Presentation to ZDRB  
May 14, 2024

# OVERVIEW OF DENSITY BONUS LAW CONCESSIONS & WAIVERS

## ZDRB MEETING SUMMARY

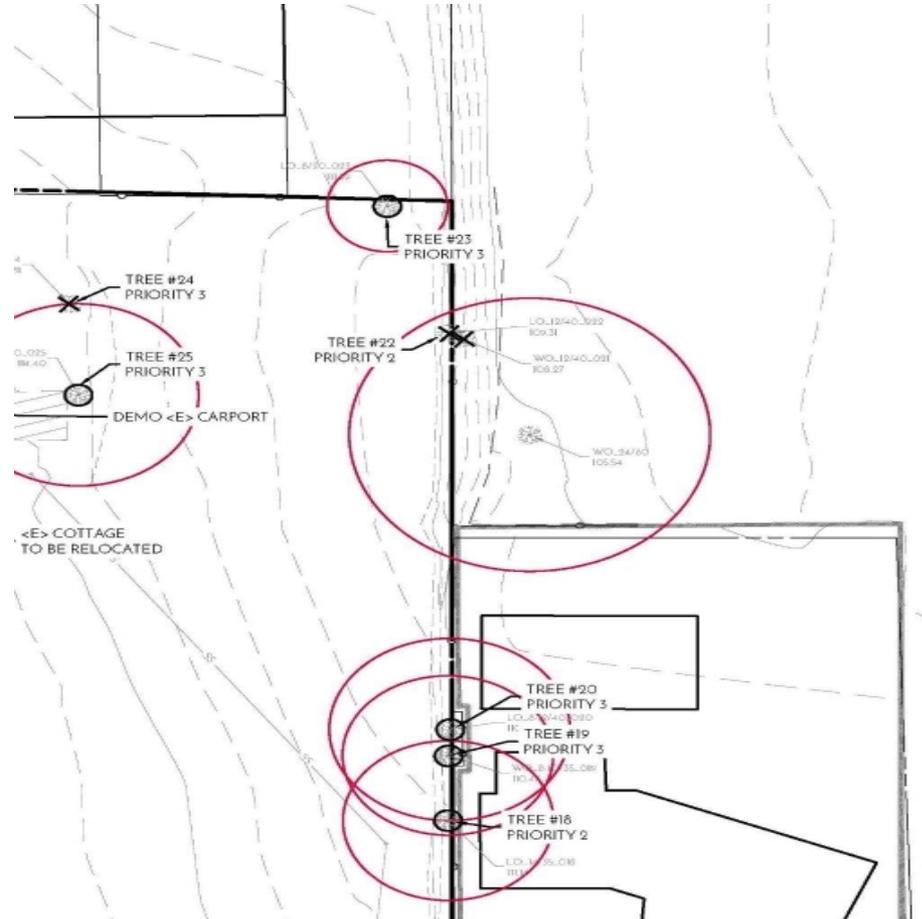
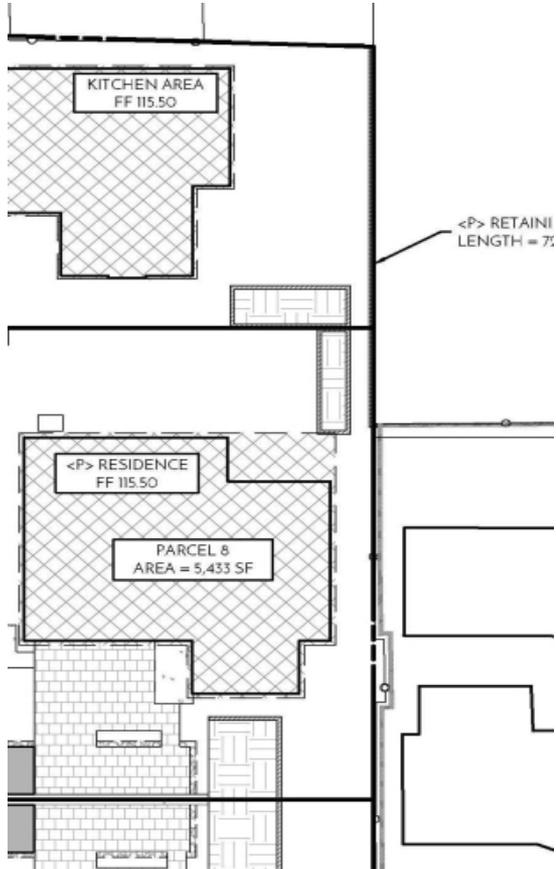
1. Relocate retaining wall to preserve Trees #21 & #22
2. Design changes to Lots 4 & 5 to address massing & neighbor privacy
3. Does entry gate have public safety impacts due to fire engine or vehicle queuing at entry?
4. Does Waiver #2—foregoing sidewalk on eastern frontage—have “a specific, adverse impact” on public safety?
5. Increasing the Town’s \$10,000 tree deposit
